PLAN OF PROPOSED IMPROVEMENT

HILL VALLEY - PHASE 1

CITY PROJECT NO. 15668
CONTRACT NO. 9643

REVISION 1 - 9/ 17/ 2025

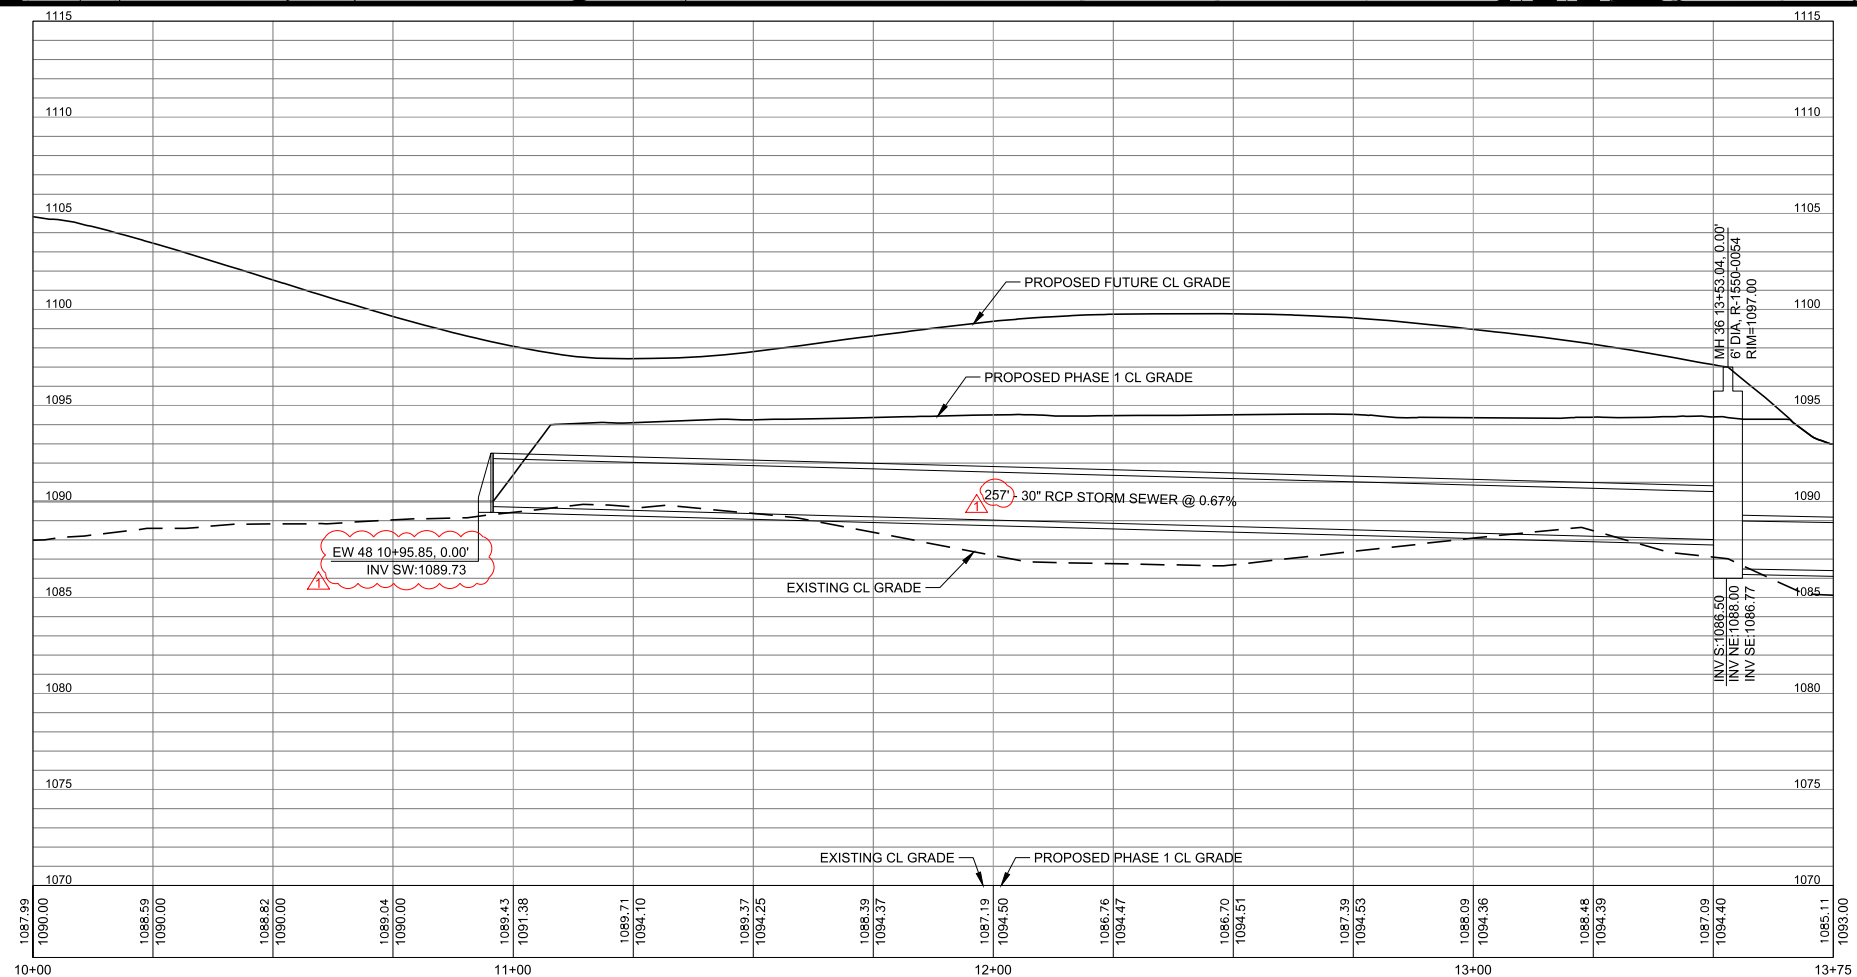
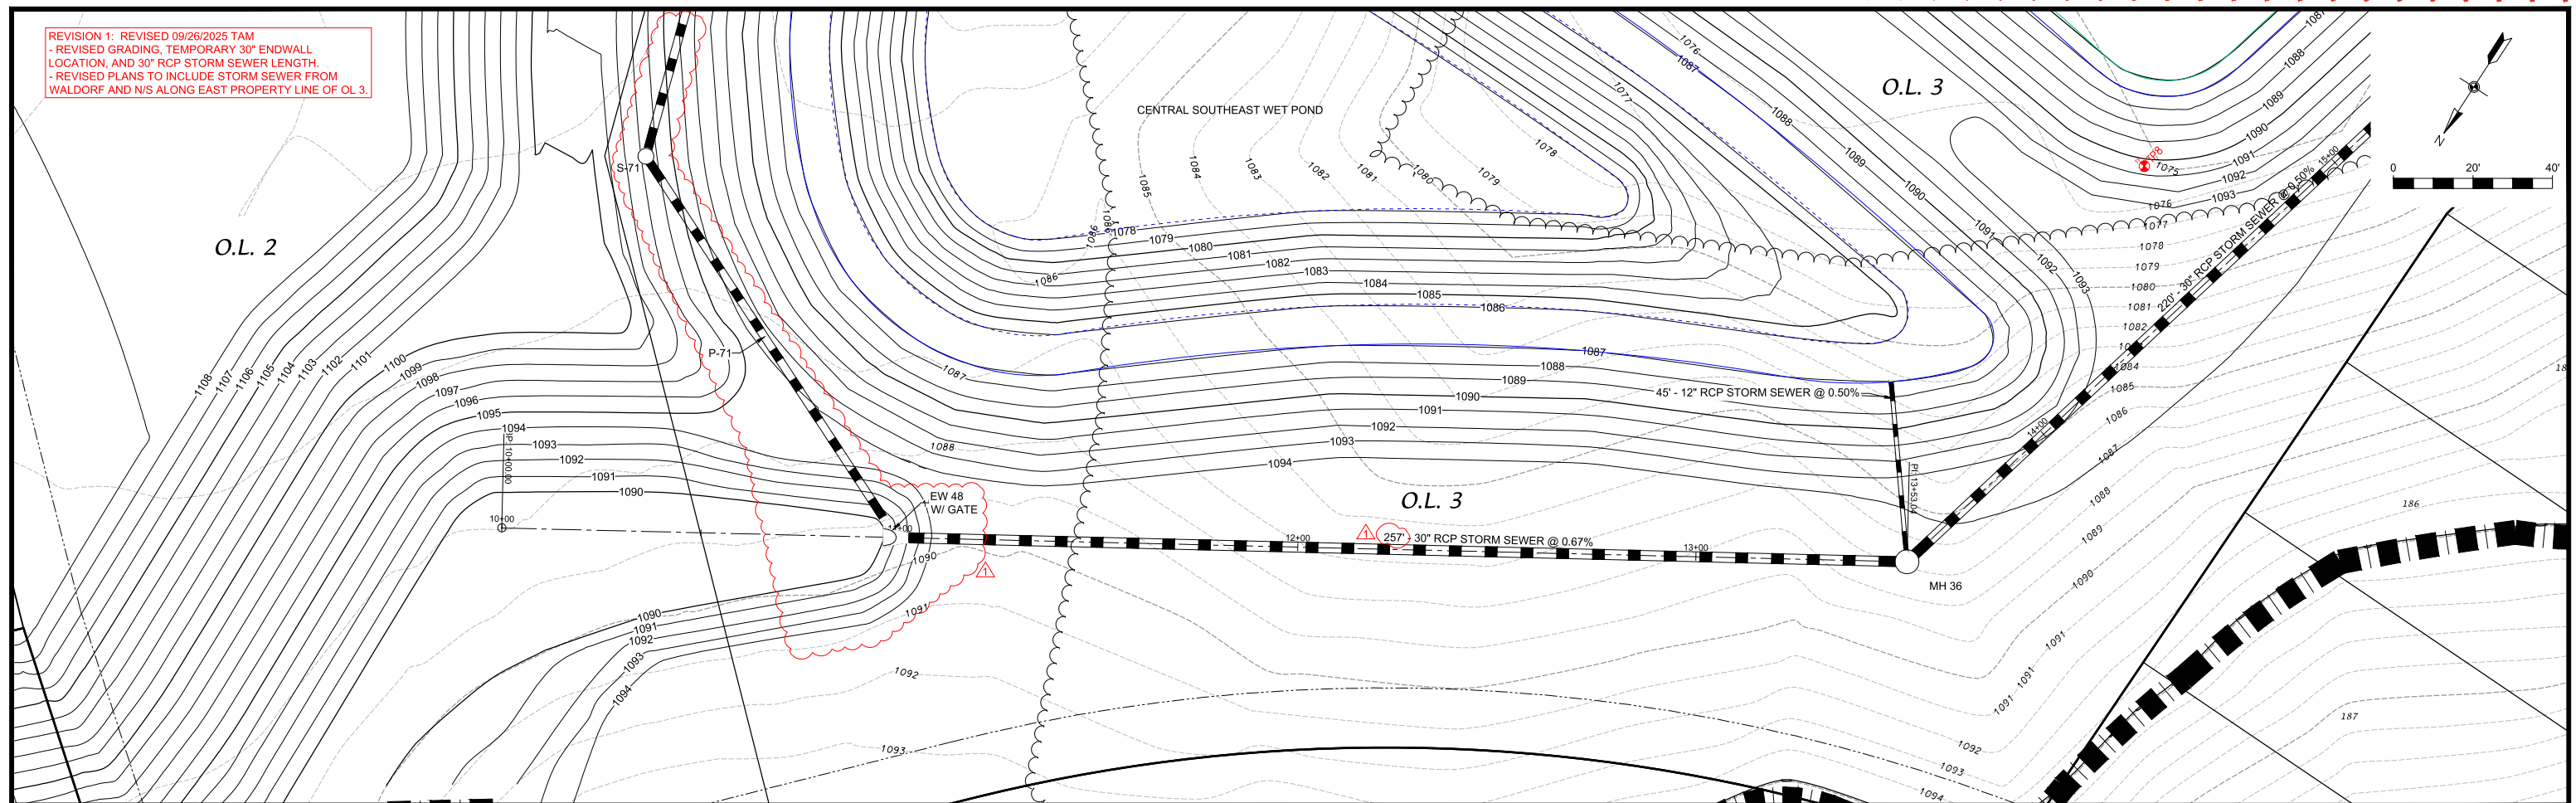
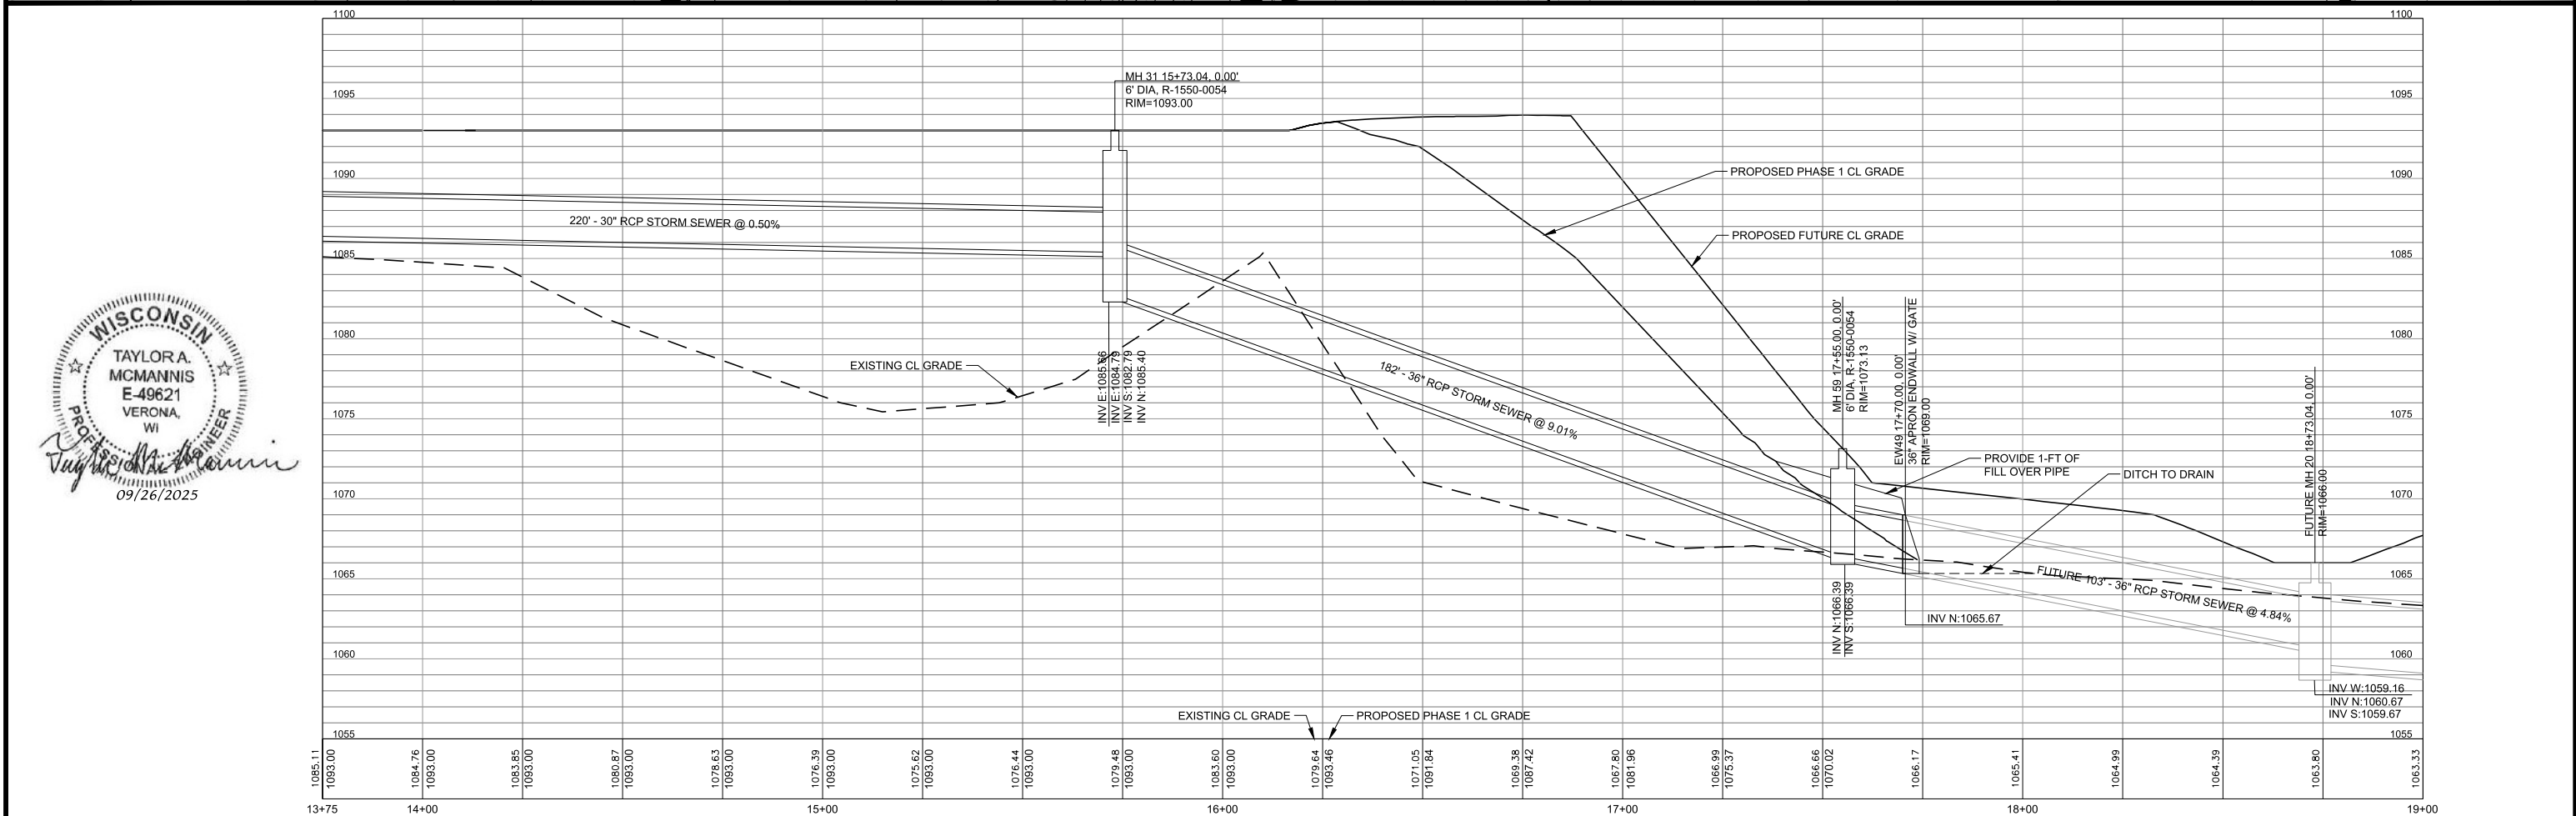
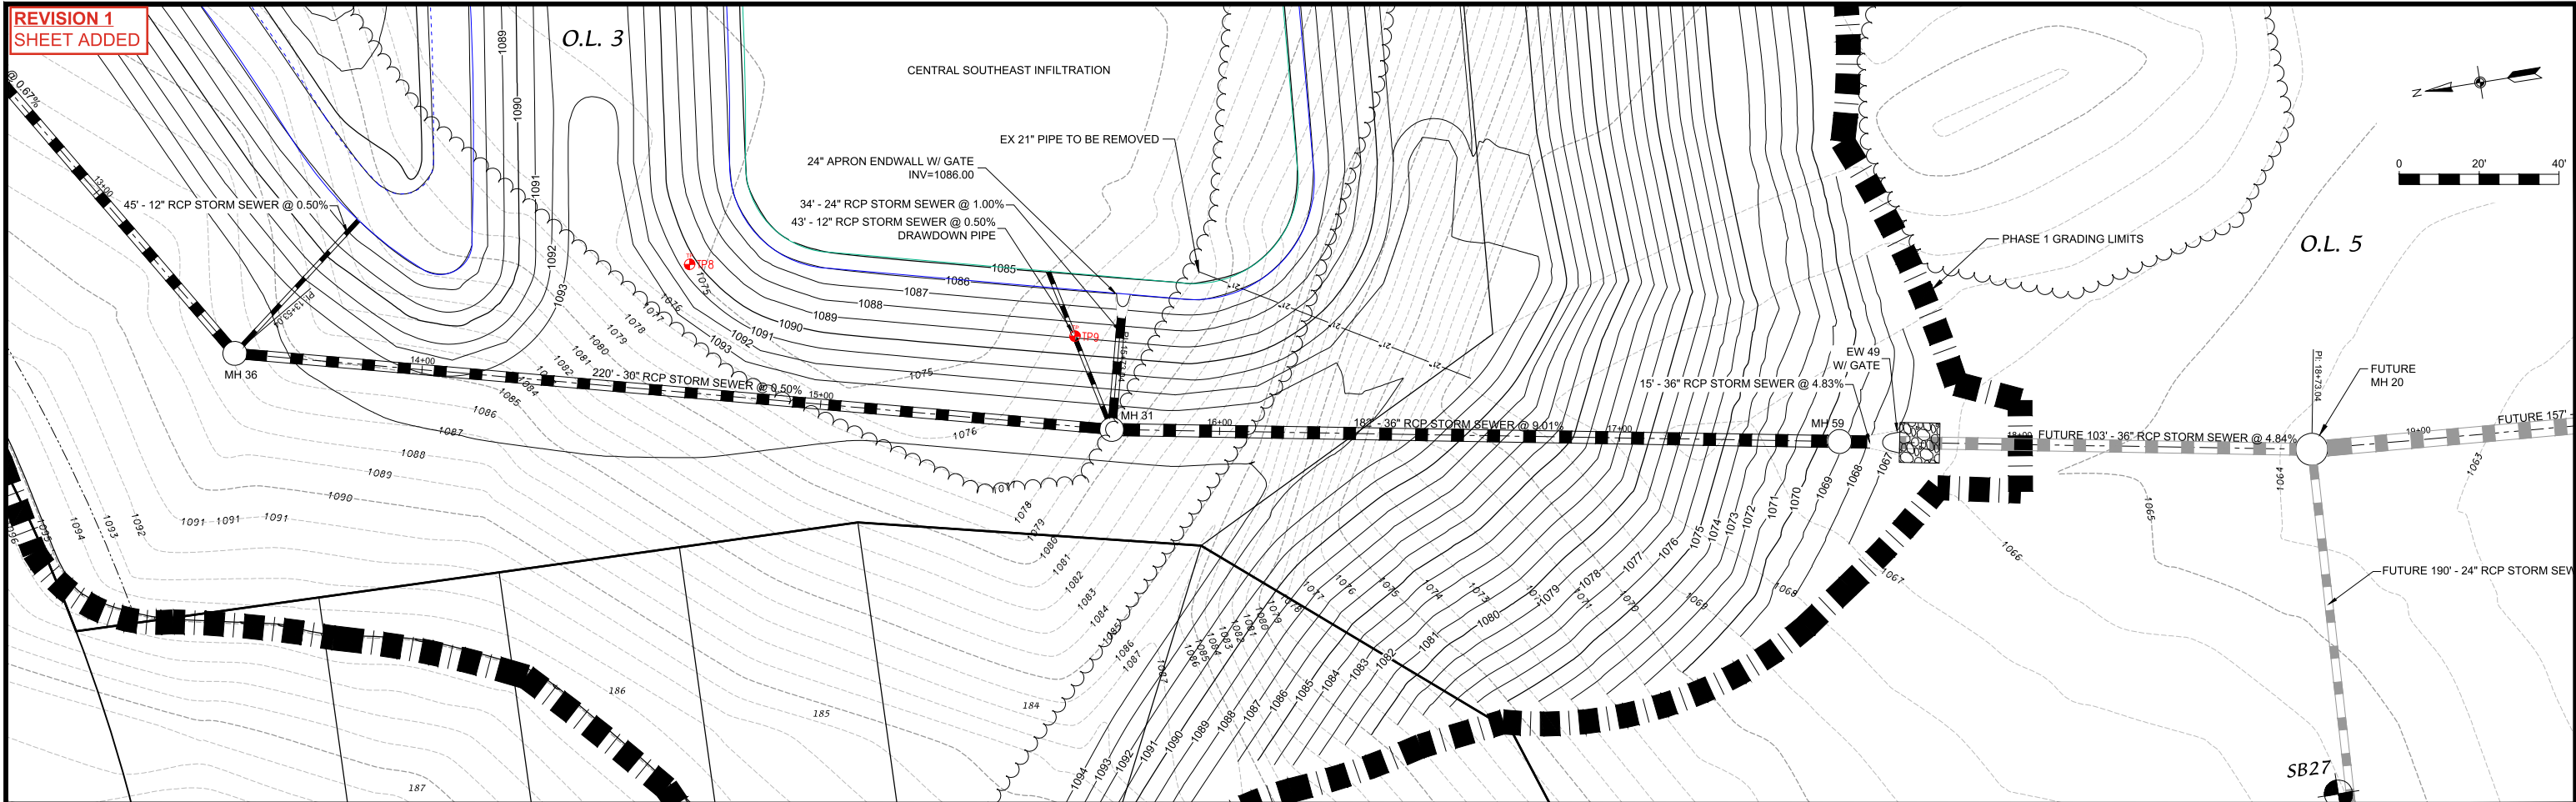
REVISION 1: REVISED 09/26/2025 TAM
- REVISED GRADING, TEMPORARY 30" ENDWALL
LOCATION, AND 30" RCP STORM SEWER LENGTH.
- REVISED PLANS TO INCLUDE STORM SEWER FROM
WALDORF AND N/S ALONG EAST PROPERTY LINE OF OL 3.
